Antelope Lakes Sewer, LL

RE: Staff's Third Set of Data Requests to Antelope Lakes Sewer, LLC
Docket #SW-20510A-07-0062

MASTER SEWER PLAN FOR ANTELOPE LAKES SEWER CO.

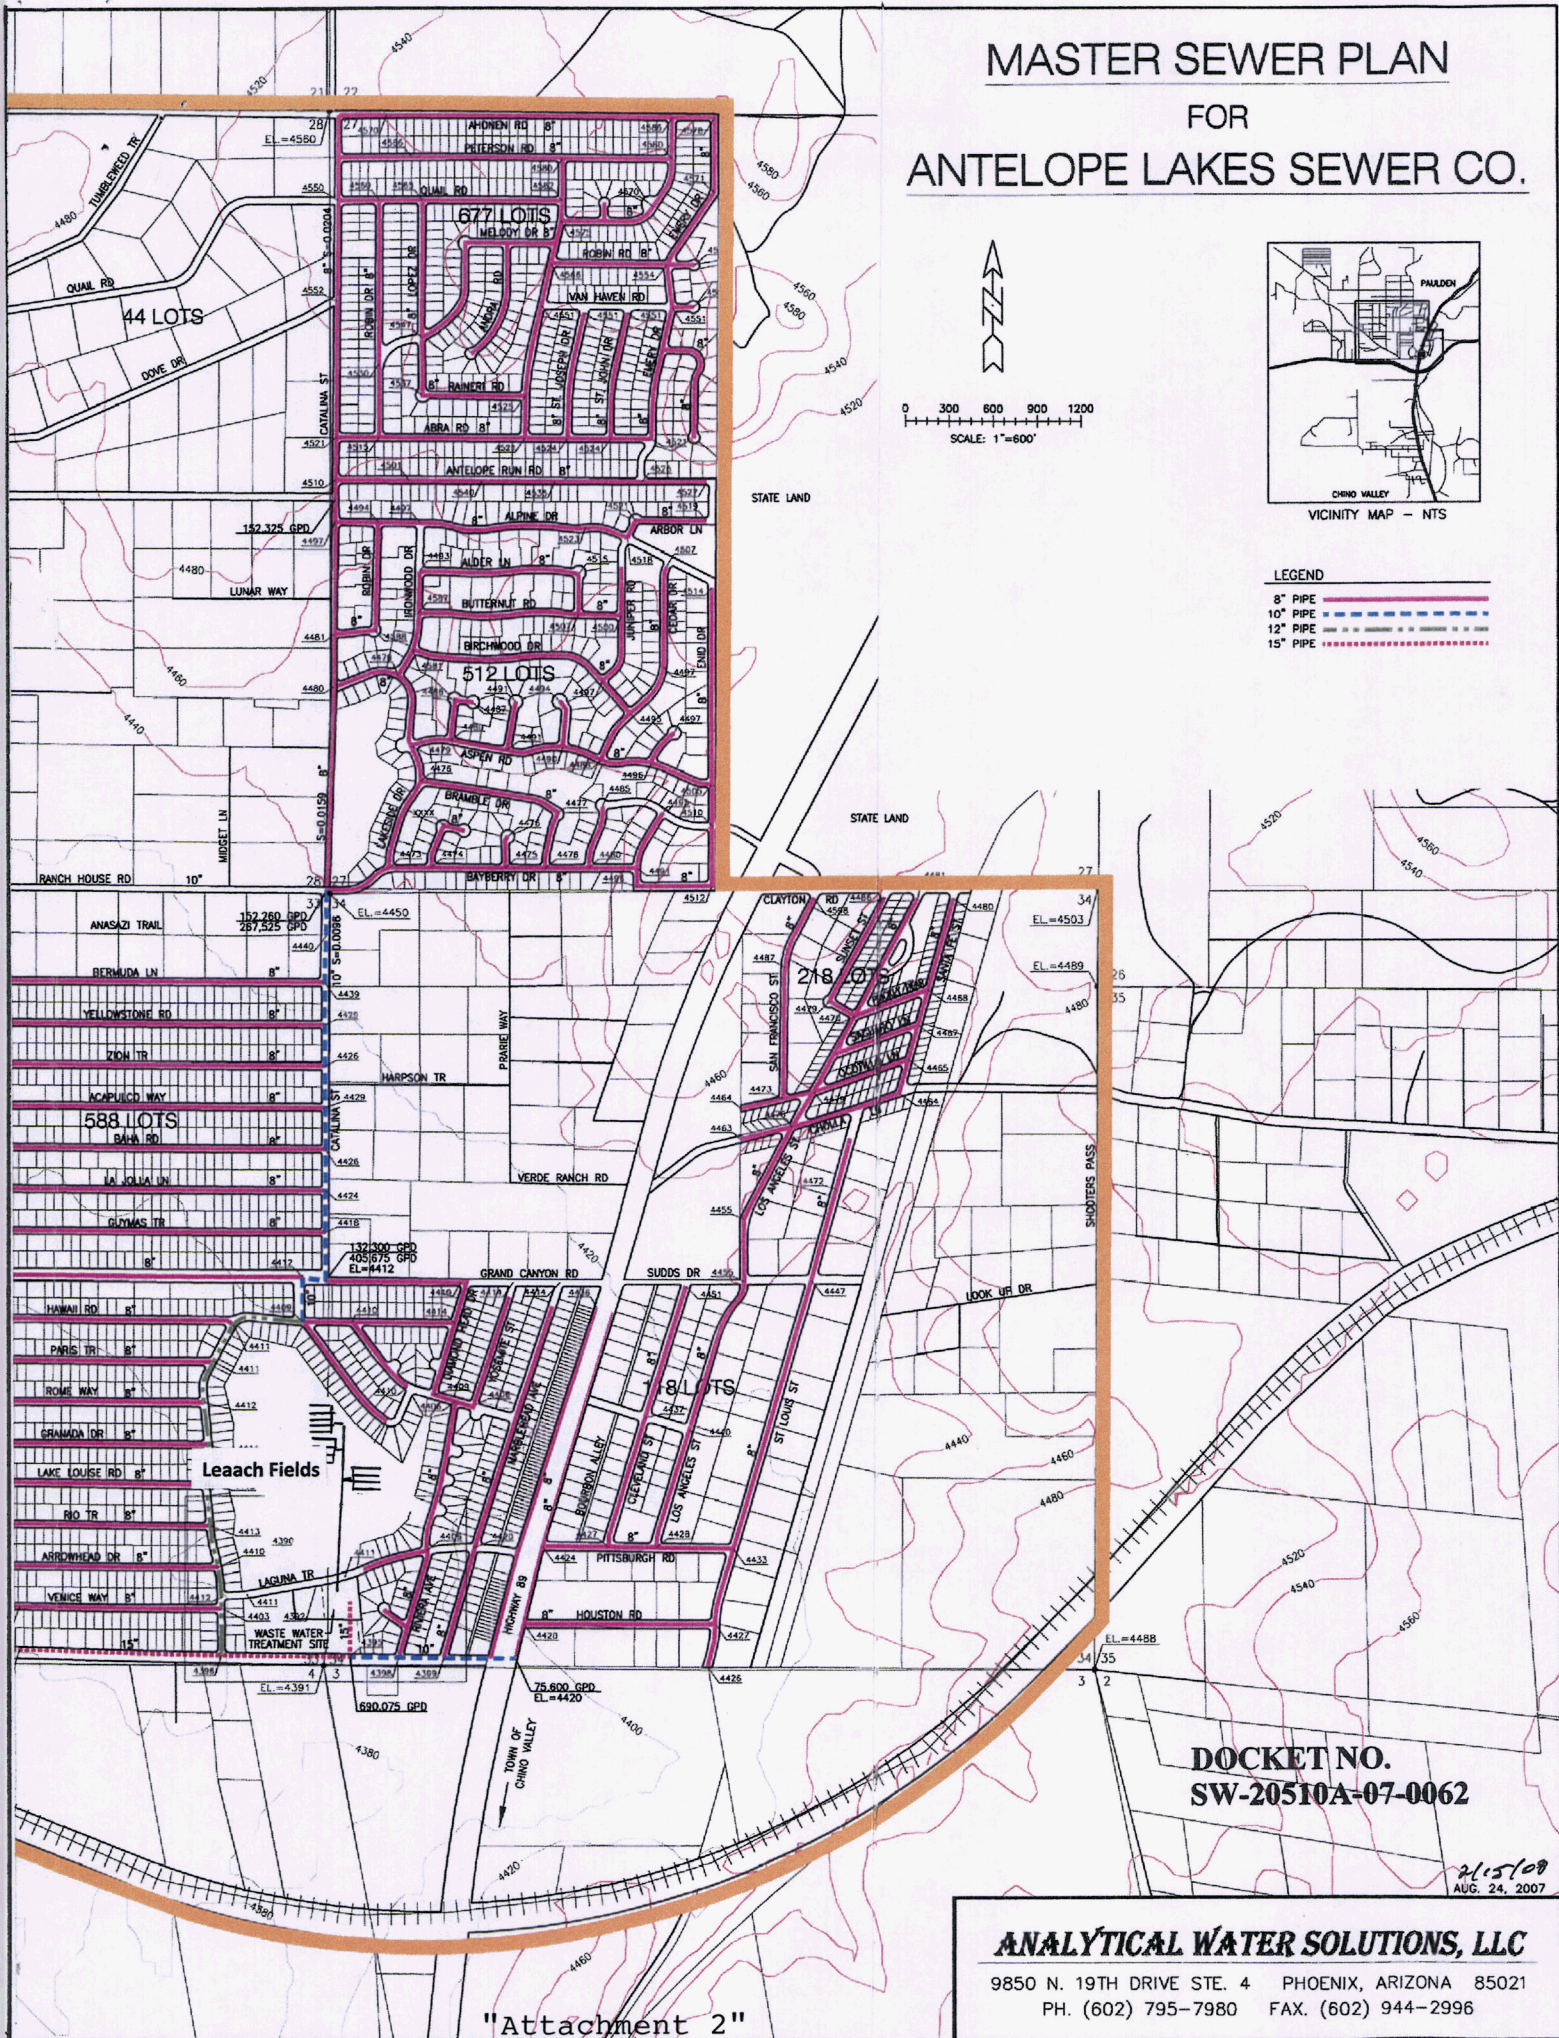
Confirm that for the proposed plant-in-service, the only effluent plant reported was the effluent lift station at an estimated cost of \$5,000.00.

If the above "A" is confirmed, the effluent system is not complete. In order to have a complete effluent system understanding, please provide:

- A. The effluent system method; i.e., recharge wells, leachfield, etc. Provide plans if available.
- B. The detailed cost estimate of the selected effluent system.
- C. Who will be responsible for funding of the effluent system.

The effluent lift station estimated at \$5,000.00 is the correct amount for the lift station, however, the leach field was omitted. The Master Sewer Plan, included herewith as "Attachment 2", has been revised to show the leach lines. The leach lines with the proper engineering for percolation rates and sizing will be submitted to Arizona Department of Environmental Quality (ADEQ) as part of the Aquifer Protection Permit (APP).

The effluent disposal for the first two phases will be leach fields. Plans are to be submitted to ADEQ as part of the APP application.

"Attachment 2" is the Master Sewer Plan for Antelope Lakes Sewer, LLC. Please note that the leach fields have been drawn into the plan to show the location where they will be engineered.
